# J4 and 87 pit dewatering project TROILUS GOLD CORP

Answers to the questions and comments  
by the MELCC and COMEX

Troilus Gold Corp

April 2020

Figure 1 – Section N13400 Showing exploration target on the east wall of 87 pit. Also shown : historical drill holes.

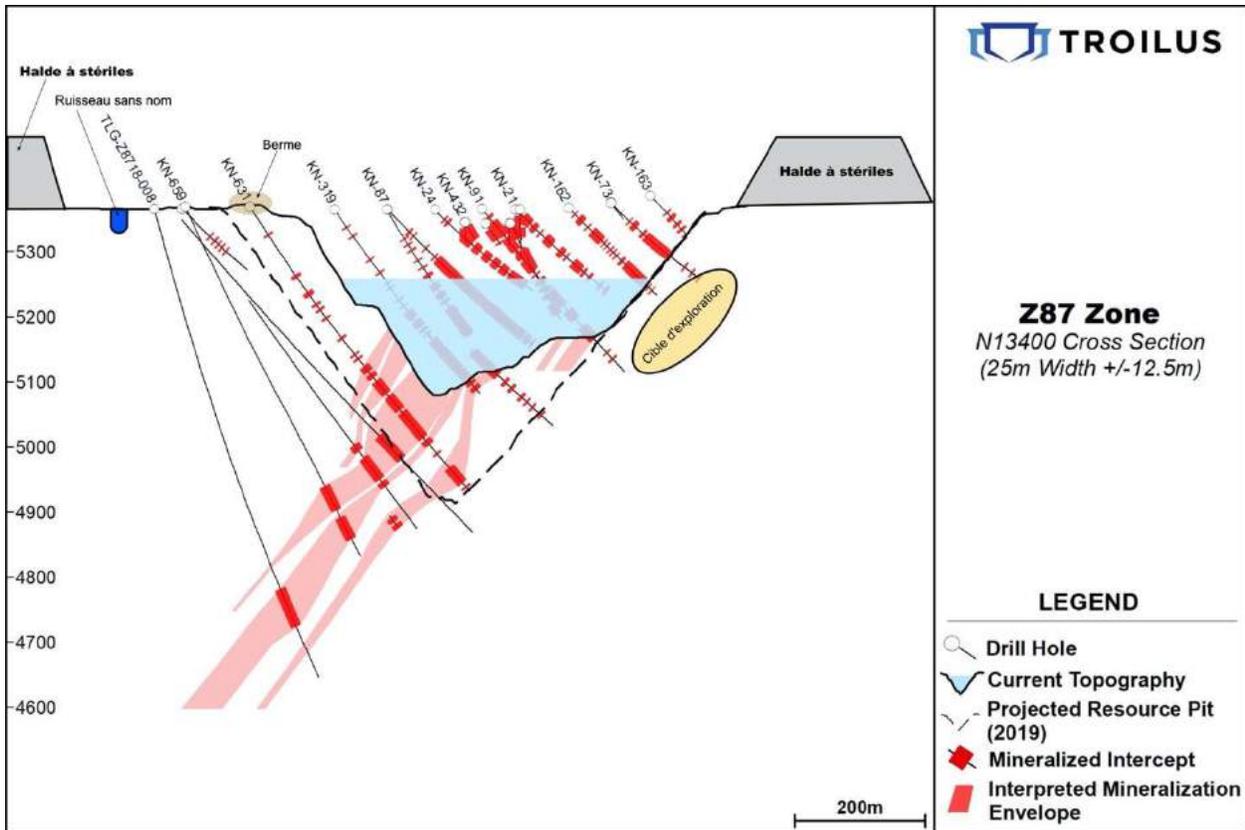
- I. TROILUS GOLD must provide further explanation as to why the dewatering of the 87 pit is necessary if drilling is to be conducted from the J4 east wall

*Troilus gold Corp: The drilling will also be conducted in the east wall of the 87 pit, as shown in the next figure.*

**Figure 1- Water surface temperature Troilus 2019**

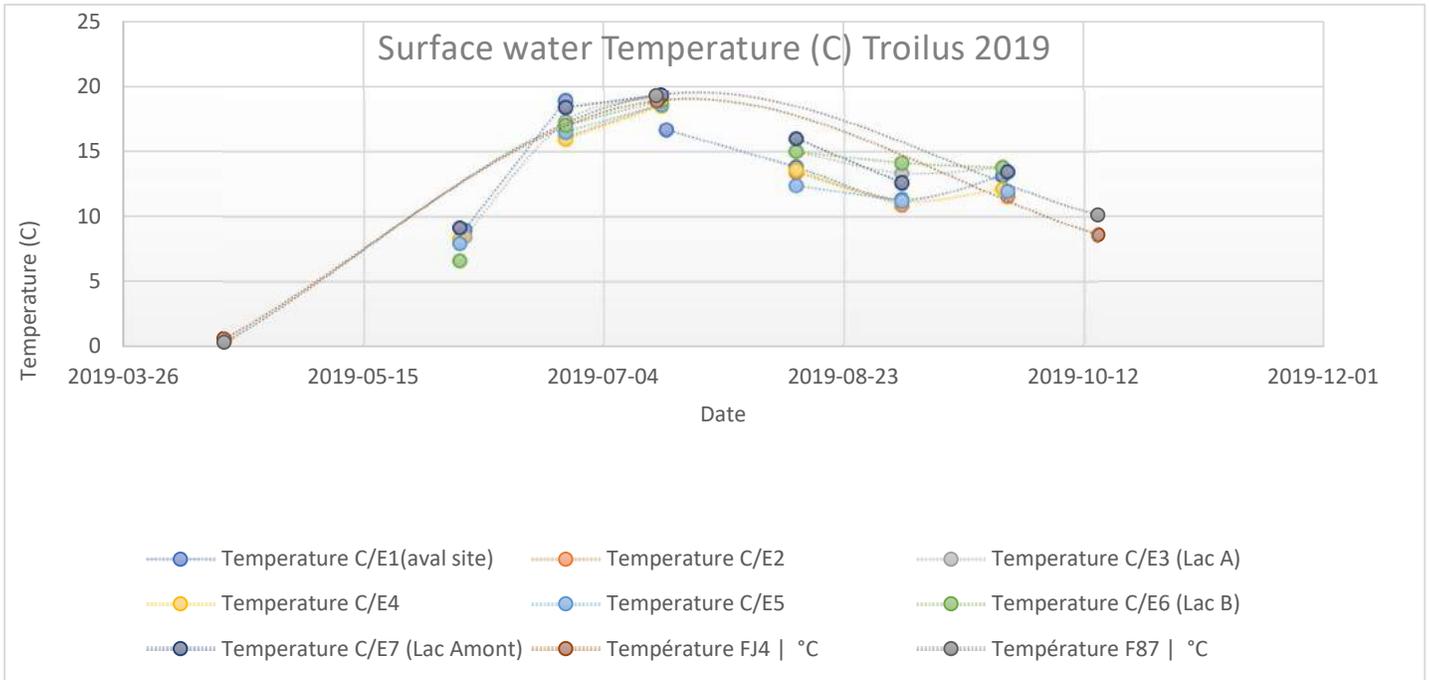
II. The company must demonstrate that the thermal conditions of the stream will not be significantly modified following the discharge of water from the pits into the stream.

*water temperature taken at several points in the unnamed stream and in both pits during 2019 indicate that the surface water temperature in the pits does not appear to differ significantly from that of the unnamed stream. See figure 1 (FJ4 and J87 correspond to Pit J4 and Pit 87)*
